Access Compliance Report

Public Rights-of-Way

(Pedestrian Signals)

Intersection ID: N/A	Main Street:	Cross Street: N/A	Location: N/A
ADA ID: 58F5FACD05E3	Signal Type: One Push Button-APS	Overall Compliance: No	Severity Score: BTN 1: N/A BTN 2: N/A No BTN: N/A
Codes/Mitigation Info/Possible Solution		Field Measurements/Component Compliance

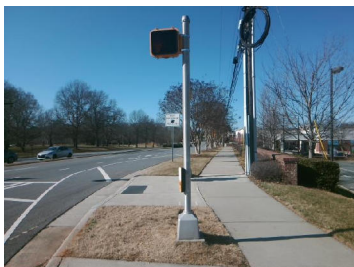
PROW/ADA: R209.1, TMUTCD 4e.08, R410.6, R404.3, R404.1, R404.7.1, R404.7.2, R104.2,

Possible Solutions: Remove & Replace Sign. Provide PAR As Indicated. Provide Clear Space.
